400 series Palazzo / X73A (UMA/DIS) Schematics

PROJECT : 400 SERIES
Quanta Computer Inc.

Size	Document Number	Rev
	Block Diagram	1A
Date: Friday, July 24, 2015	Sheet 1 of 62

Size	Document Number	Rev
	Carrizo 1/7 (PCIE)	1A
Date: Friday, July 24, 2015		Sheet2 of 62

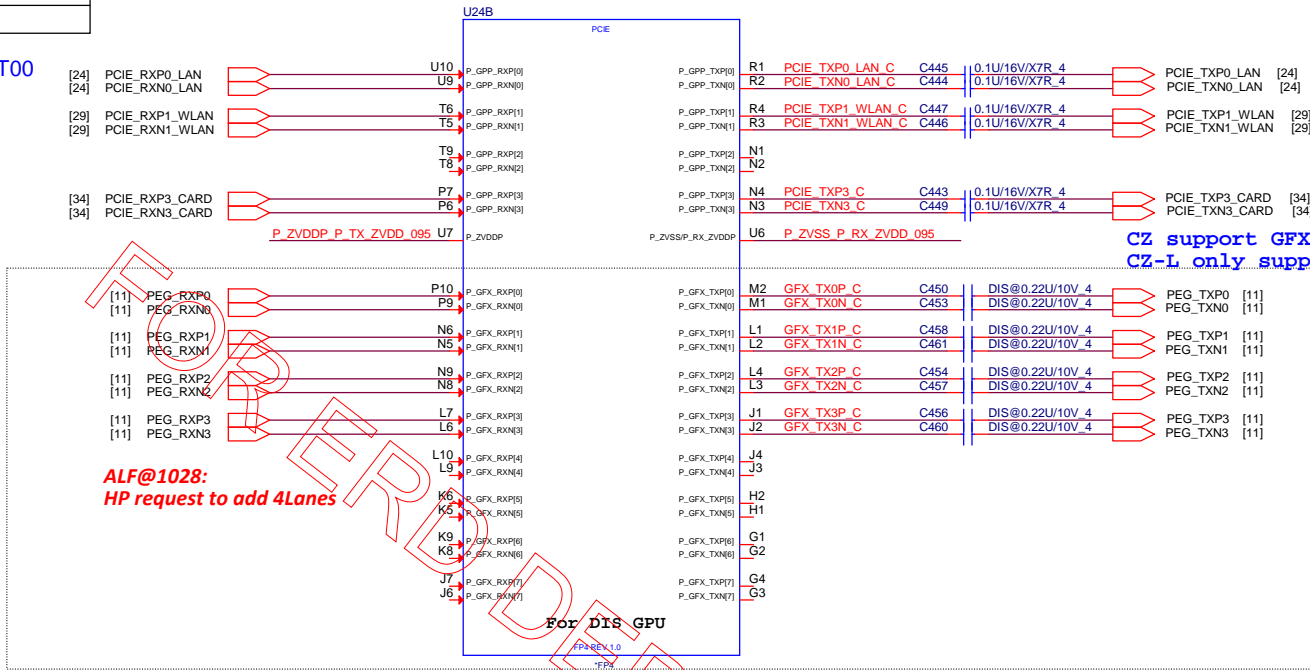
ALF@1028:
HP request to add 4Lanes

Size Document Number Rev 1A
Carrizo 277 (MEM)

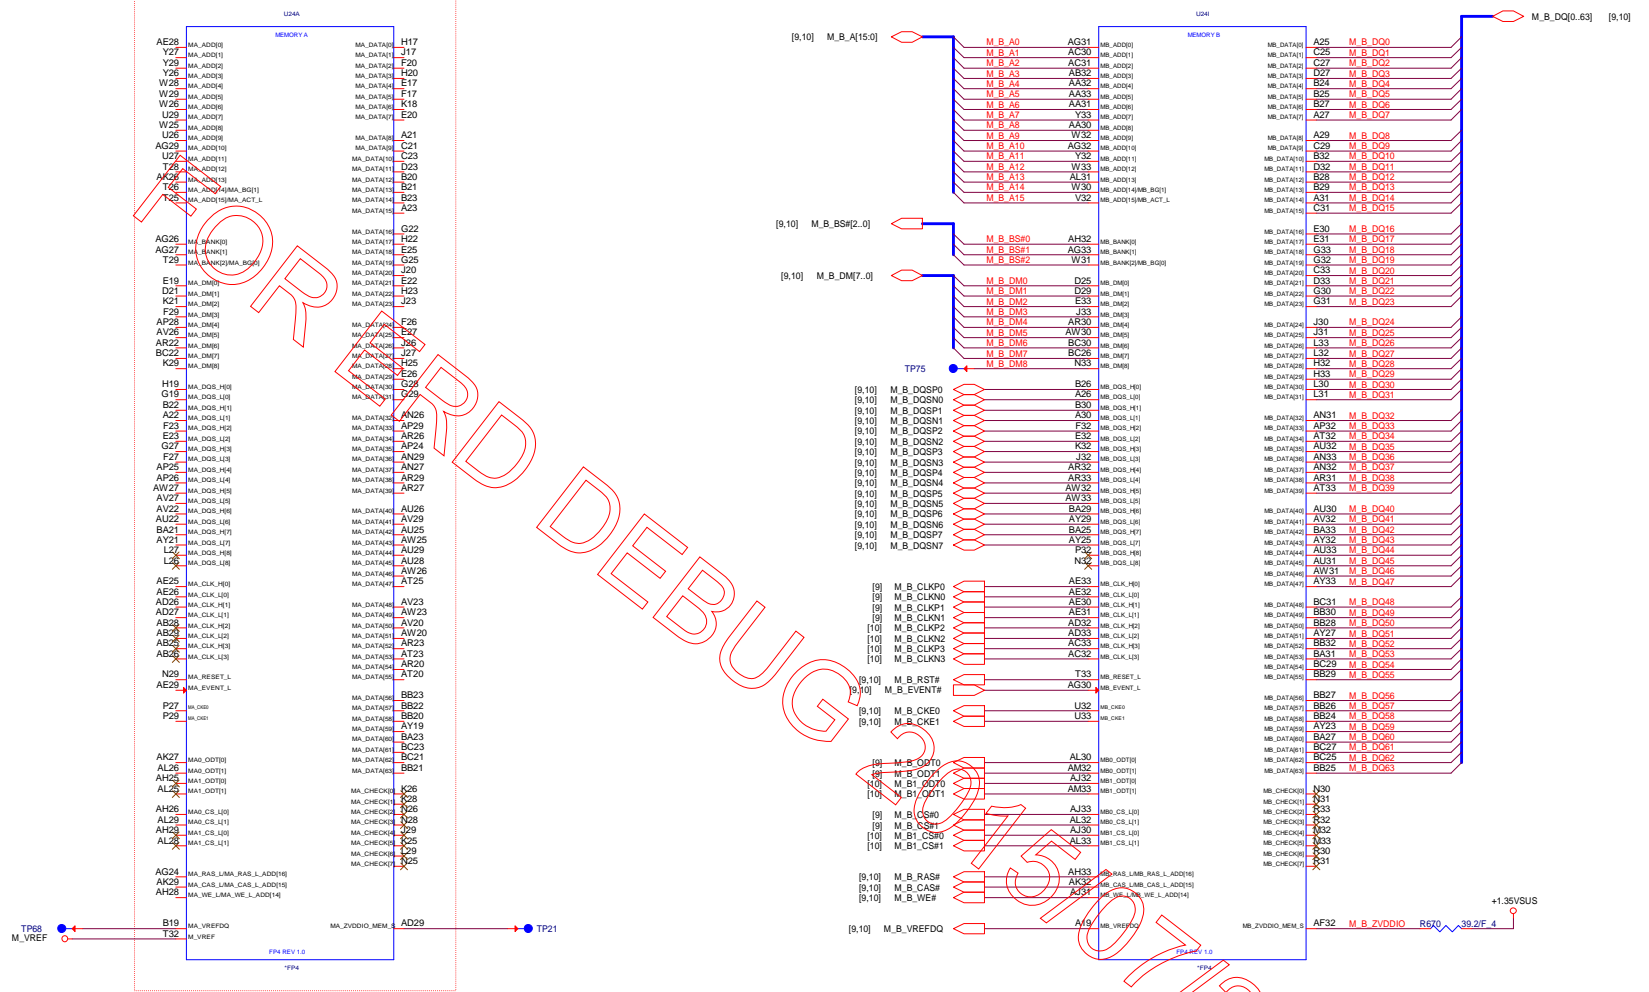
Ronny@1013:
2 So-Dimm per Channel (B)

1013@RNY: Also need to check AMD whether it can float or not?
1102@RNY: AMD recommend reserve test point at VREFDQ/ZVDDIO_MEM_S

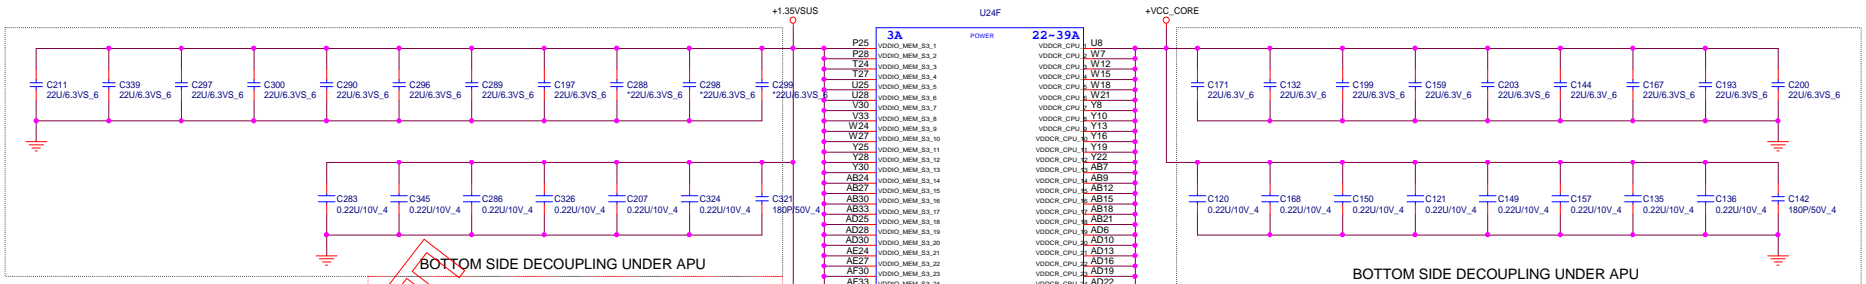
1029@RNY: follow Leading NC
PV, 0415, follow AMD DG to PD LPC_PD_L, no used

Size Custom	Document Number System Memory 2/2 (4H)	Rev 1A
Date: Friday, July 24, 2015		Sheet 10 of 62

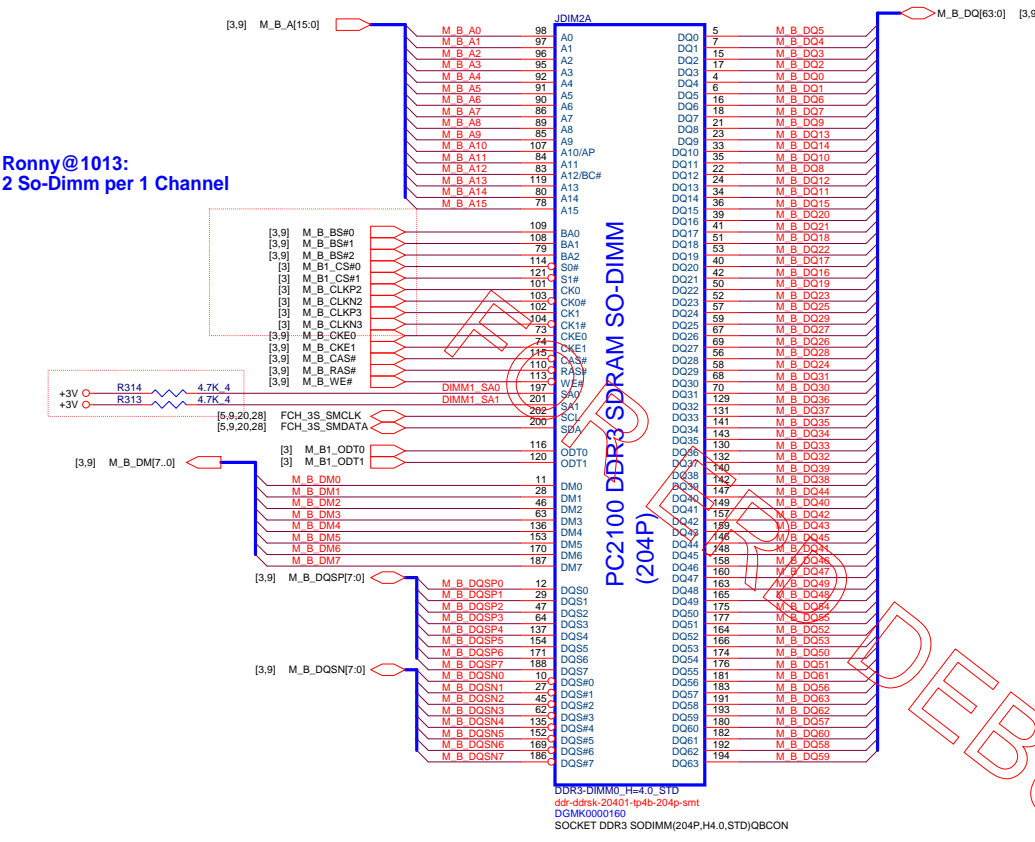
Ronny@1013:
2 So-Dimm per 1 Channel

1028: Ronny
delete DDR thermal IC, please refer to Page41

NB5	PROJECT : 400 SERIES Quanta Computer Inc.	
	Size Custom	Document Number Finger Printer
Date: Friday, July 24, 2015		Sheet 17 of 62

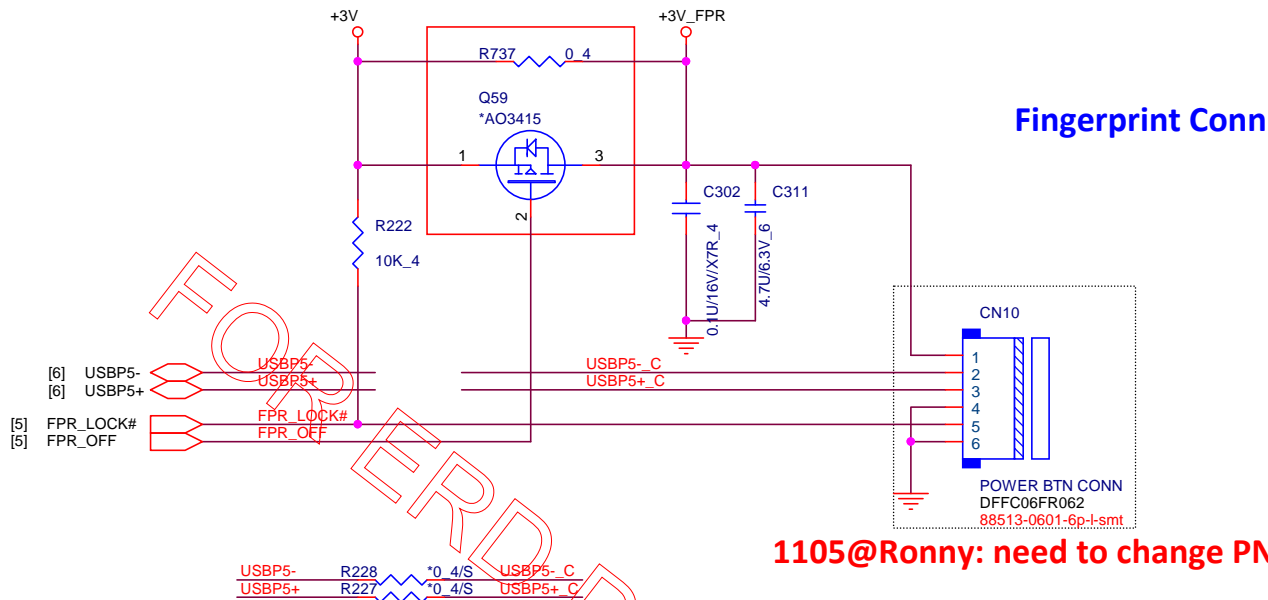
PV, 0415, follow leading project to add MOSFET for FPR_OFF

PROJECT : 400 SERIES		Rev 1A
	Quanta Computer Inc.		
	Document Number LCD CONN/LID/CAM-D-MIC	Sheet 19 of 82	
Size Custom	Date: Monday, July 27, 2015

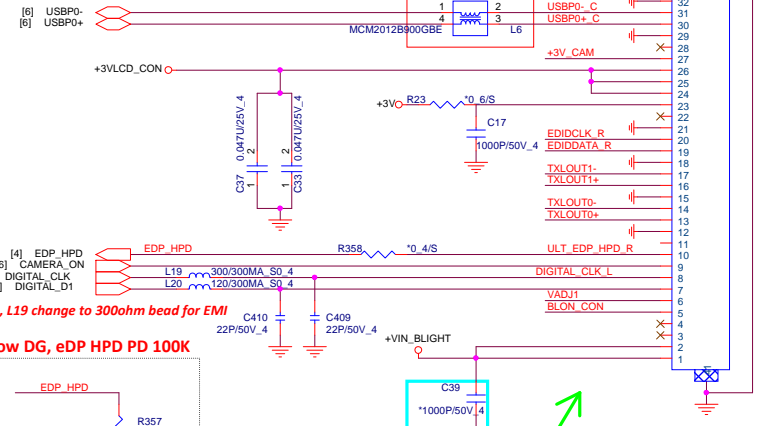
PV, 0421, L19 change to 300ohm bead for EMI

1029@RNY: follow DG, eDP HPD PD 100K

Size Custom Document Number DP to VGA Rev 1A
Date: Friday, July 24, 2015 Sheet 20 of 62

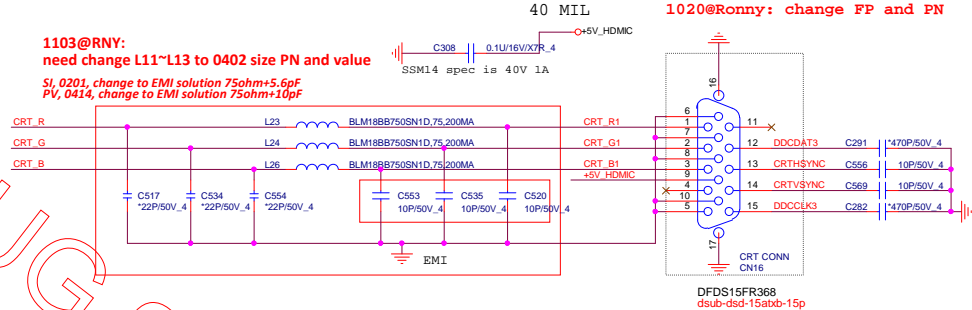
1103@RNY:
need change L11~L13 to 0402 size PN and value
SI, 0201, change to EMI solution 75ohm+5.6pF
PV, 0414, change to EMI solution 75ohm+10pF

Size Custom	Document Number TPM SLB9665_QFN	Rev 1A
Date: Friday, July 24, 2015		Sheet 26 of 62

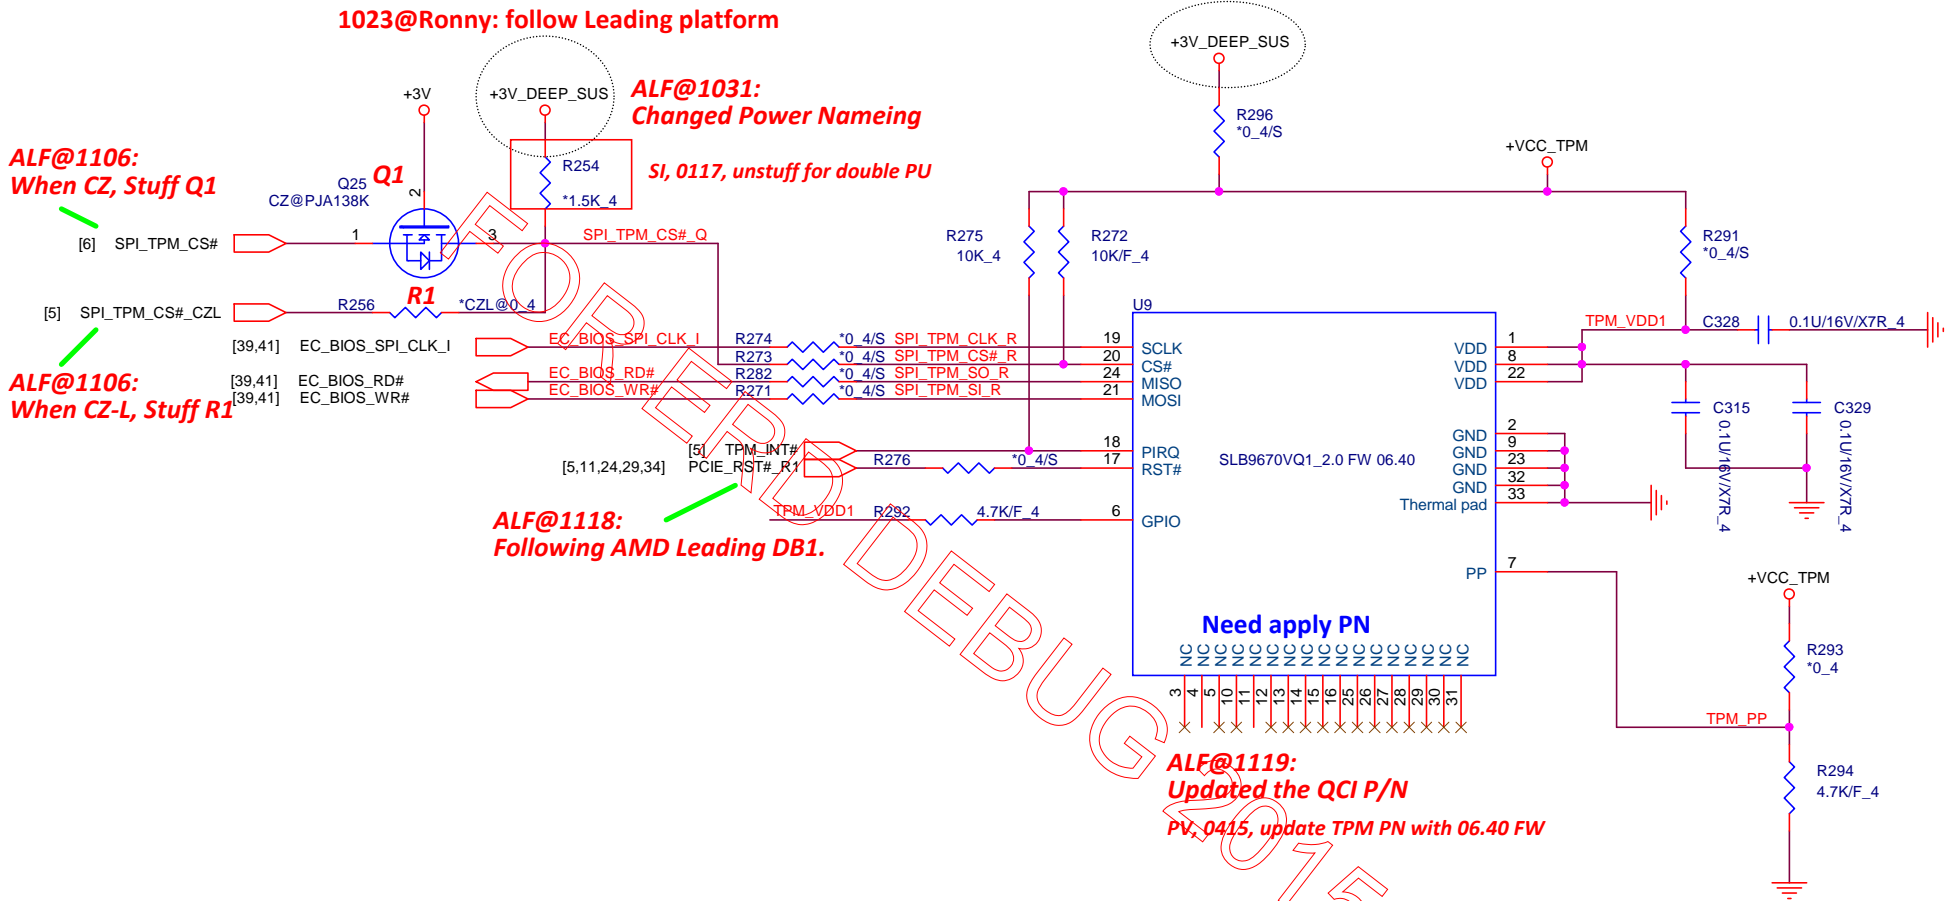
ALF@1106:
When CZ, Stuff Q1

ALF@1106:
When CZ-L, Stuff R1

ALF@1118:
Following AMD Leading DB1.

ALF@1119:
Updated the QCI P/N
PV, 0415, update TPM PN with 06.40 FW

Size Custom	Document Number USB 3.0/USB3 Re-driver	Rev 1A
Date: Friday, July 24, 2015		Sheet 27 of 82

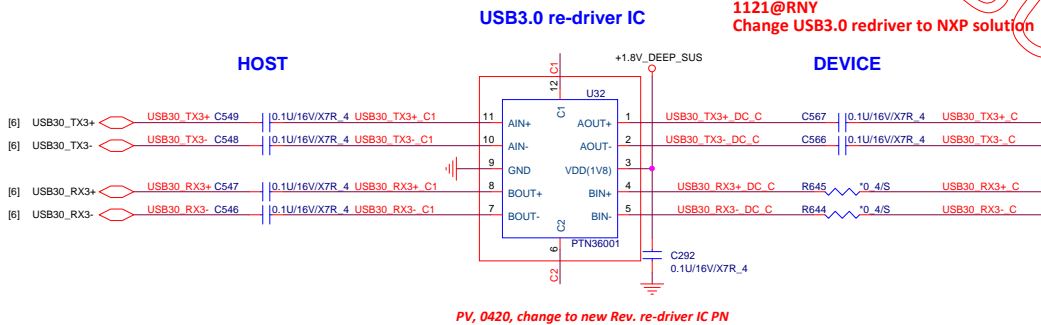
1016: Alfred
 Added USB3.0 Re-driver for Lower Left.

Layout Notes:
 Stubs Trace less than 150mil
 1112@ALF Deleted the bypass way, due to the space limitation.

PROJECT : 400 SERIES		Rev 1A
	Quanta Computer Inc.		
Size Custom	Document Number Accelerometer		
Date: Friday, July 24, 2015	Sheet 28 of 82

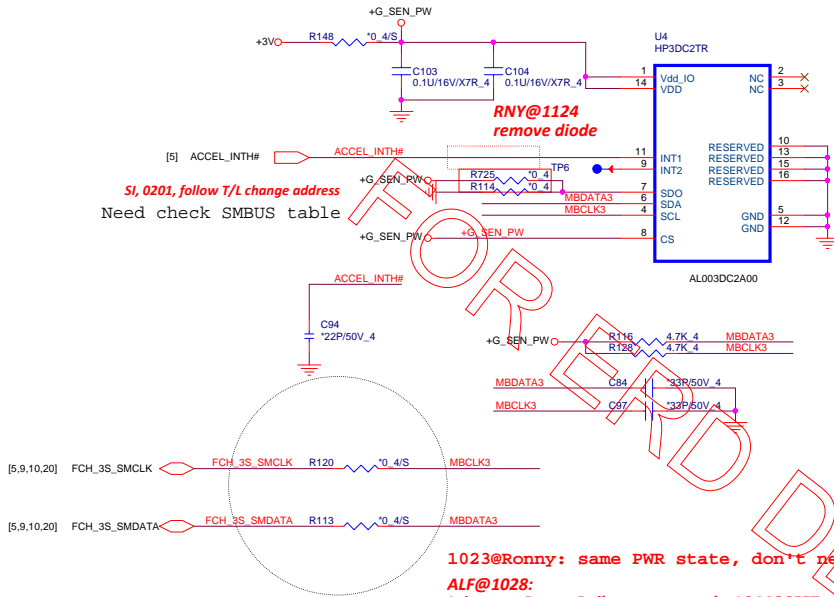
G-Sensor Power need check

ALF@1028:
HP Confirmed, 400 Series AMD does NOT support the Touch Screen.

1028@Ronny:
need change pin define

PROJECT : 400 SERIES		Rev 1A
	Quanta Computer Inc.		
Size Custom	Document Number		
	33 -- PB/LID		
Date: Friday, July 24, 2015		Sheet 33 of 82

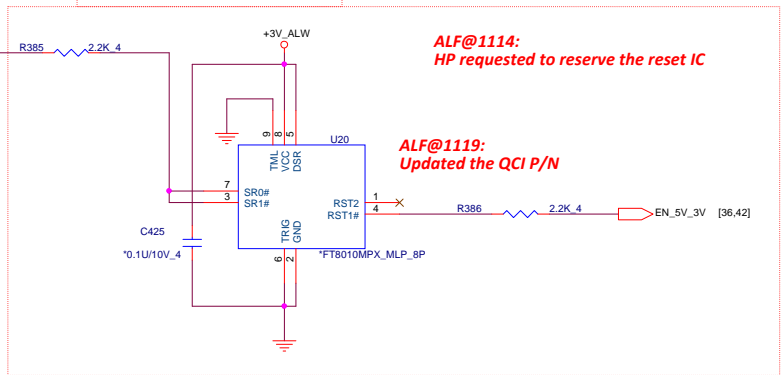
ALF@1115:
HP requested to modify the Power Switch.

SI, 0211, change LED R to 330 PV, 0414, change LED R to 470

ALF@1114:
HP requested to reserve the reset IC

NB5	Size Custom	Document Number 34 -- Forced Pad/Card reader	Rev 1A
	Date: Friday, July 24, 2015	Sheet 34 of 82

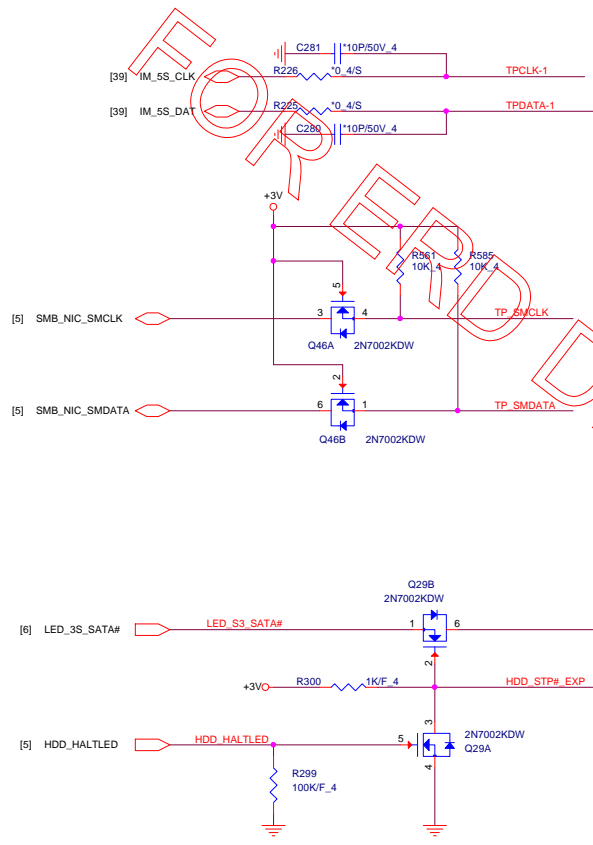
PV, 0414, remove CN9.8 CR_WAKE#

PV, 0420, delete R722

PV, 0415, change 430ohm for lightness tuning

Size B	Document Number 37 -- HDD/ODD	Rev 1A
Date: Friday, July 24, 2015		Sheet 37 of 62

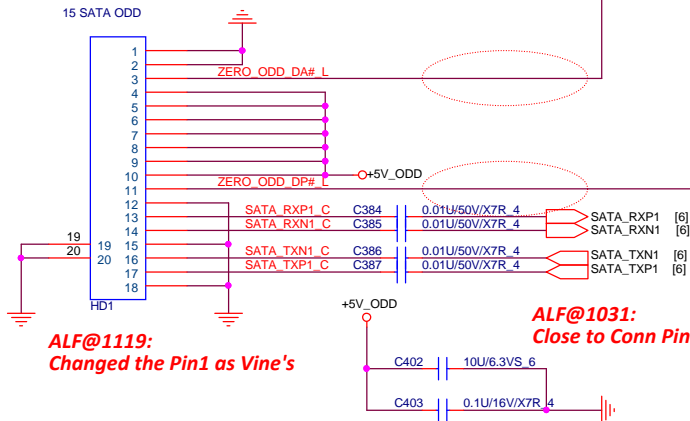
ALF@1031:
HP requested to add the ZPODD for 400 Series

- GPIO PIN needs to check with HP:**
1. ZERO_ODD_DA#
 2. ZERO_ODD_DP#
 3. ODD_PWR
